Subject: KNOCKING NOISE FROM REAR SUSPENSION WHEN DRIVING OVER ROAD BUMP	Bulletin No: 02-013/16
	Last Issued: 08/01/2016

APPLICABLE MODEL(S)/VINS

2014-15 Mazda3 vehicles (Mexico built) with VINs lower than 3MZBM*****200038 (produced before March 2, 2015)

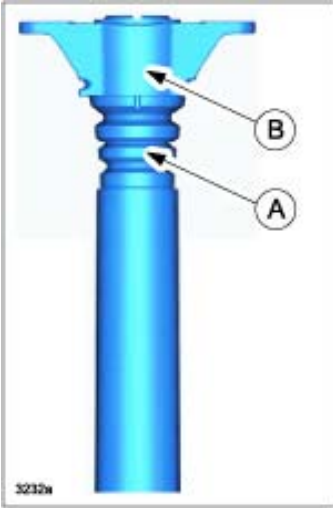
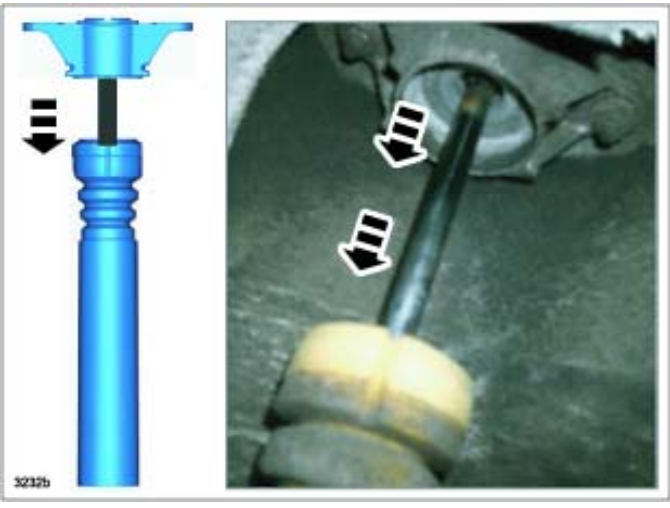
Some vehicles may exhibit a knocking noise from the rear of the vehicle when driving over a road bump. This may be caused by the bump stop (bound stopper) for the rear shock absorber coming out of the mounting rubber. To eliminate the concern, the bonding agent and the area to be covered have been changed to increase the bonding strength between the bump stop (bound stopper) and mounting rubber.

<p>Normal Condition: Bump stop (bound stopper) (A) is press fit and bonded to the mounting rubber (B).</p>	<p>Problem condition: Bump stop (bound stopper) is coming out of the mounting rubber.</p>
 <p>30232a</p>	 <p>30232b</p>

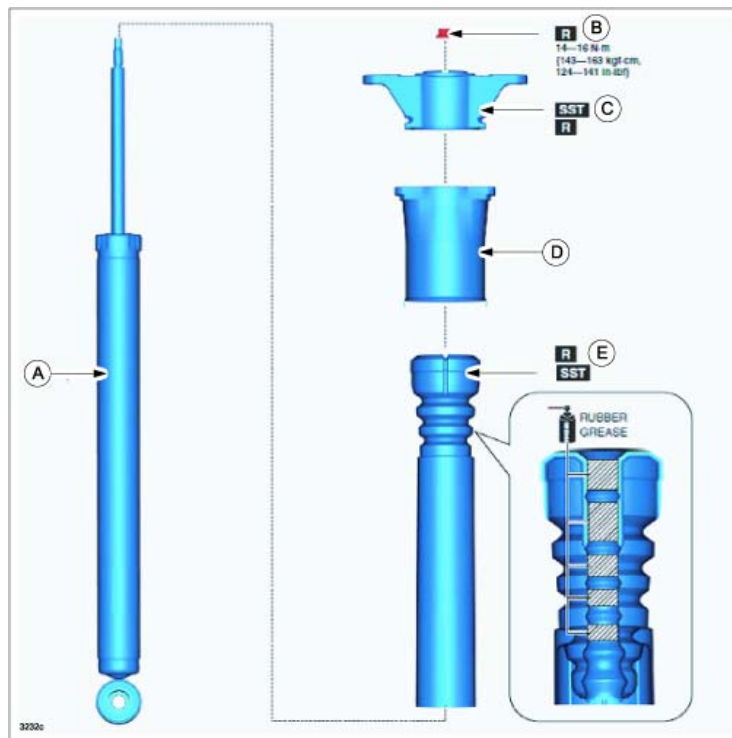
1. Verify customer concern.
2. Disassemble and assemble the affected rear shock absorber using a new bump stop (bound stopper) mounting rubber and nut according to the instructions on MS3 online (REAR SHOCK ABSORBER DISASSEMBLY/ASSEMBLY).

NOTE: All the parts in the chart are "Replacement Parts". There is no part number change by this mass-production change.
